LAWRENCE HISTORIC RESOURCES COMMISSION
AGENDA FOR **APRIL 18, 2019**
CITY HALL, 6 E 6TH STREET
6:00 PM

**LAWRENCE HISTORIC RESOURCES
ADMINISTRATIVE REVIEW
STAFF REPORT**

TO: Historic Resources Commission
FROM: Kyle Kobe, Planner I
DATE: April 18, 2019
RE: Item No. 8: DR-19-00092 1009 New Jersey Street deferred from March 21, 2019 Agenda

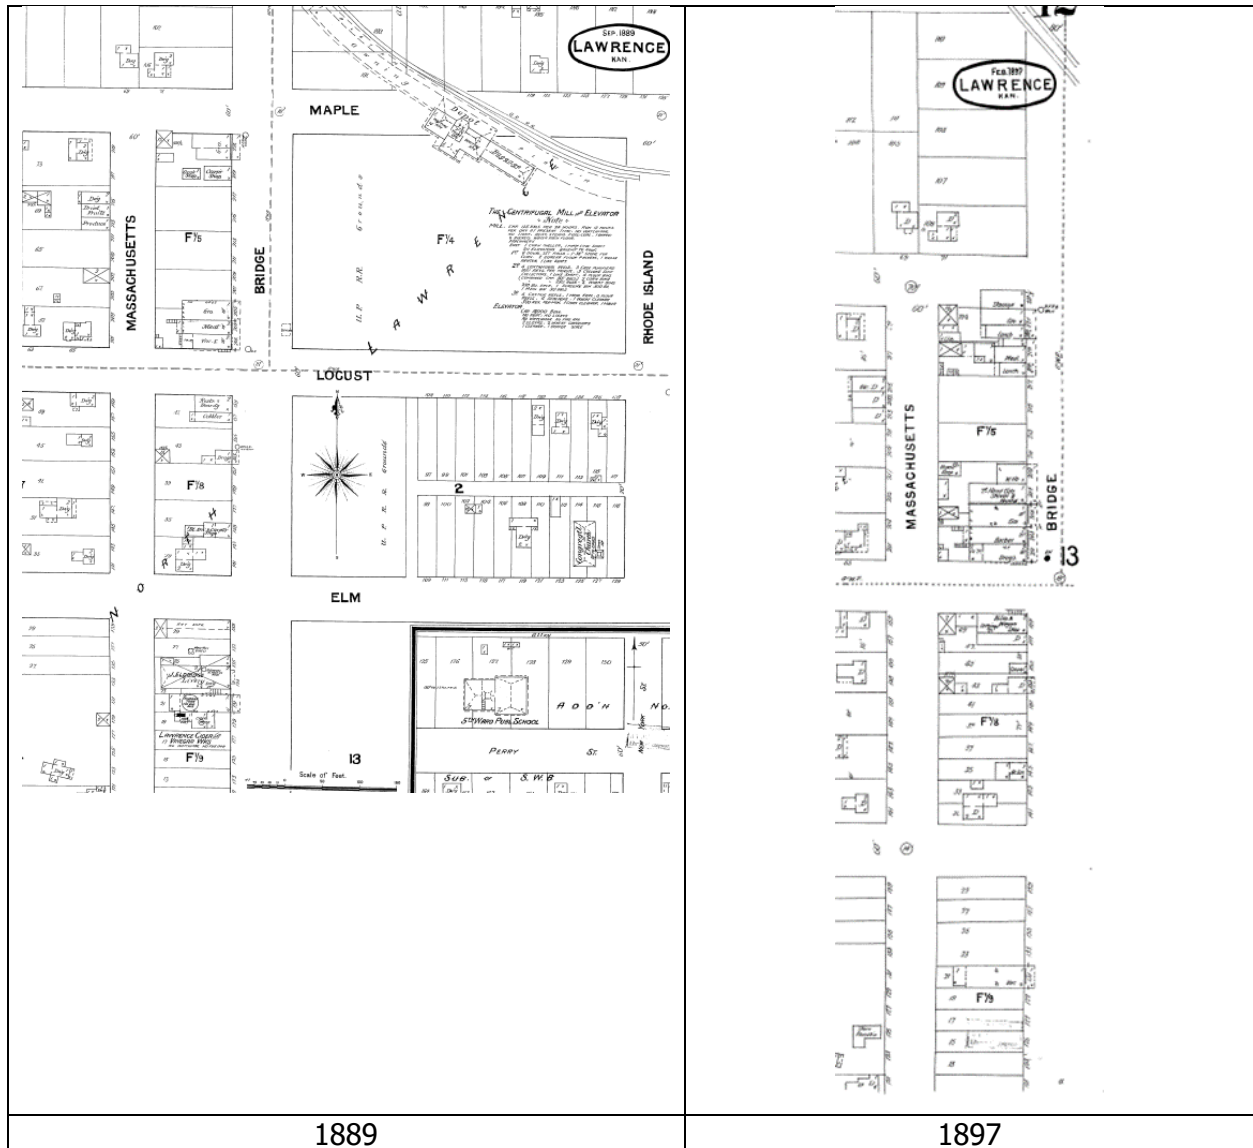
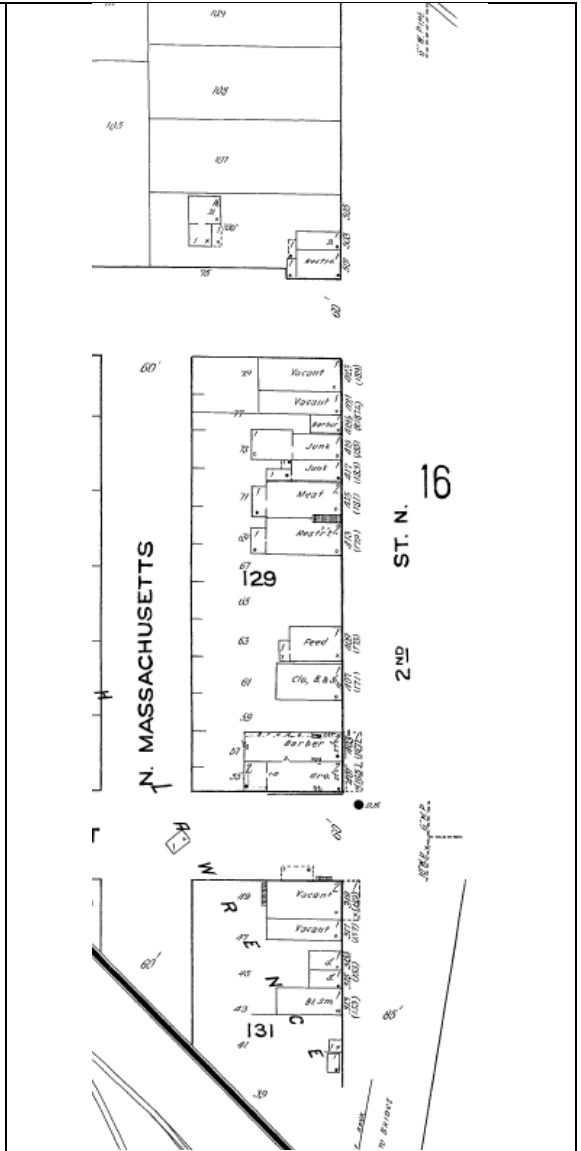
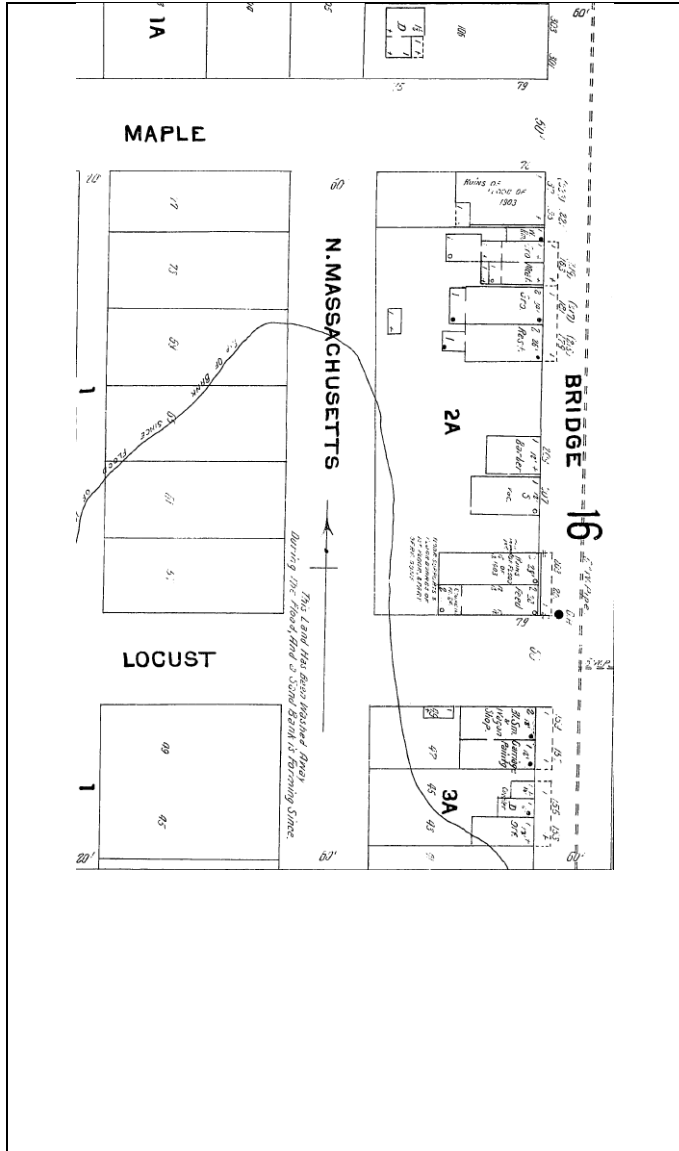
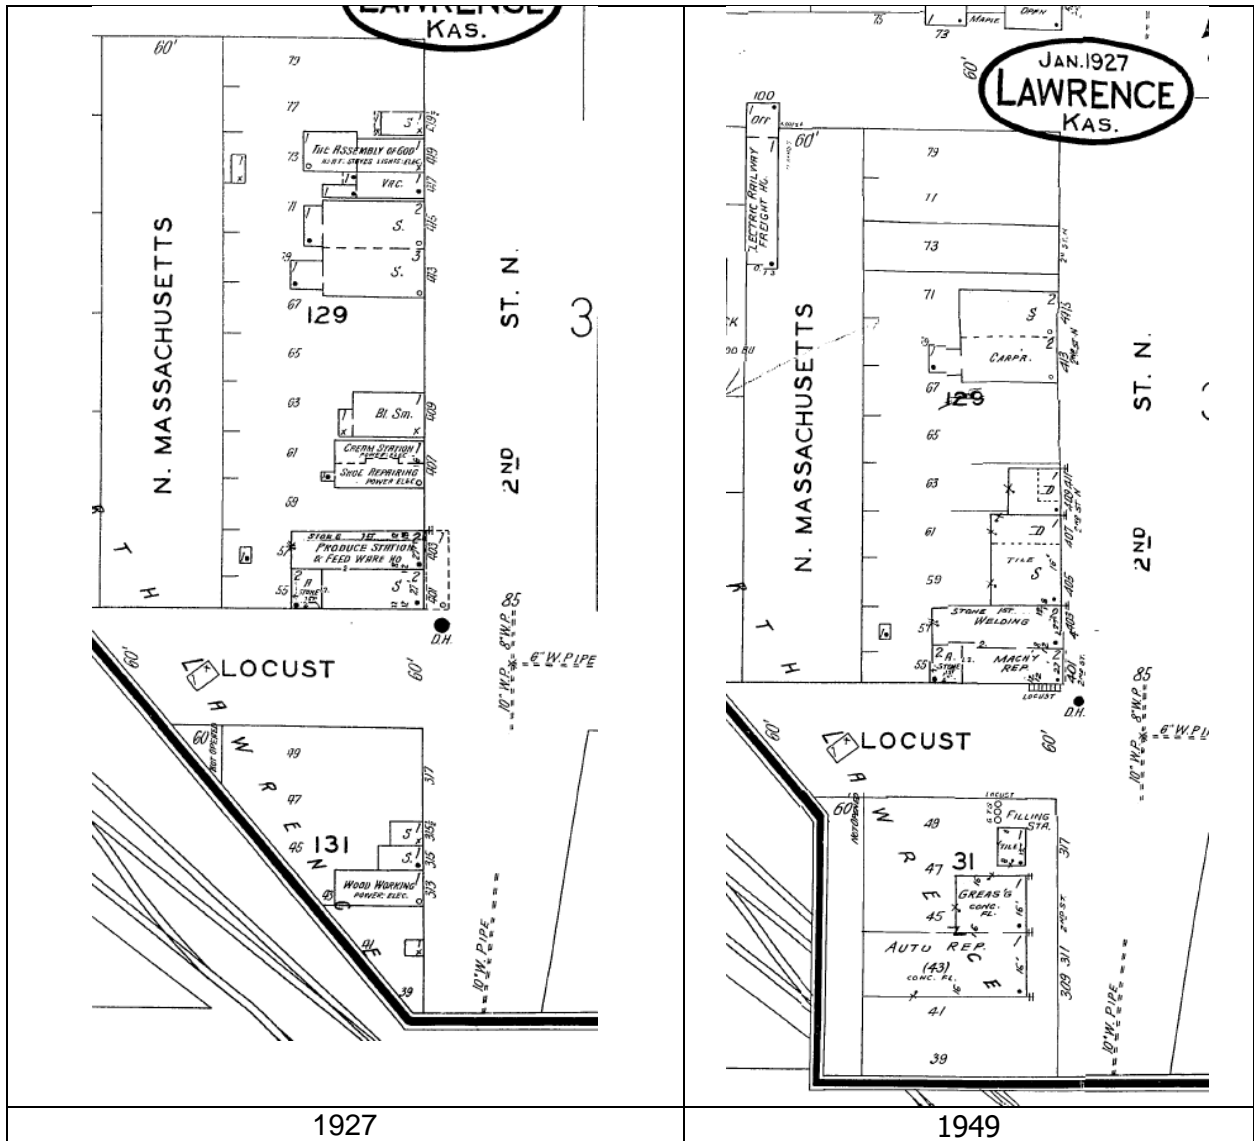
The Sanborn Fire Insurance maps show that commercial development in the 300 and 400 blocks of N. 2nd Street and residential development north of Maple Street has existed since 1889. While the four buildings proposed for demolition are no longer character defining due to the loss of the integrity of the structures, the demolition of these structures will alter the environs of the listed property. The primary character of the environs that will be impacted will be the spatial relationships, building forms, site coverage, rhythm, and height. The proposed demolition of the five structures does not meet Standard 2.

Because the demolition of structures has the potential to impact the environs of a listed property, compatible new construction should always be part of a demolition project. The applicant proposes a new structure that will front N. 2nd Street and will replace the four buildings. While this new structure has the potential to mitigate the demolition of 409 N. 2nd Street and 415 N. 2nd Street, it will not mitigate the demolition of the houses located at 501 and 505 N. 2nd Street and the grain elevator. While the demolition of these three structures will impact the environs of the Union Pacific Depot, there is no line of sight from the depot to these structures. Staff also notes that the residential area north of Maple Street has been in decline historically as a residential area and these two structures are remnants of the historic residential development of the area. Staff is of the opinion that the demolition of the houses located at 501 and 505 N. 2nd Street and the grain elevator will not damage or encroach upon the environs of the listed property.

While there is no line of sight to the grain elevator, it is shown on the development plan to be located in a parking lot island. Staff recommends the applicant consider retaining this structure as part of the overall project design.

The commercial strip in this area has historically had structures that were one or two stories in height. Currently the environs has no structures over two stories in height. The building that is directly to the south, 401 N. 2nd Street is two stories. (A new one story addition will be added to the north.) The guidelines for new construction recommend new structures relate to the height of adjacent structures. As a general rule, new buildings should be constructed to a height roughly equal to the average height of existing buildings for the historic period on and across the street. New construction that greatly varies in height from older buildings in the vicinity should be avoided. (Section 22-506.1) The proposed five story structure does not meet this guideline. The new structure will be placed approximately 10 feet from the one-story addition to 401 N. 2nd Street. Being adjacent to a one-story structure with a minimal separation will amplify the disparity height between the new structures. The new structure will not be compatible with the environs of the listed property.

The height of the structure directly relates to the scale and mass of the structure. The applicant has designed the structure with a pedestrian storefront system and building division with varying rooflines and materials to address the scale and mass of the building. An architectural language between the pedestrian level storefront and the upper floors of the structure could provide additional compatibility with the environs.

The ARC recommends the HRC approve the revised project as shown on the attached drawings and rendering.
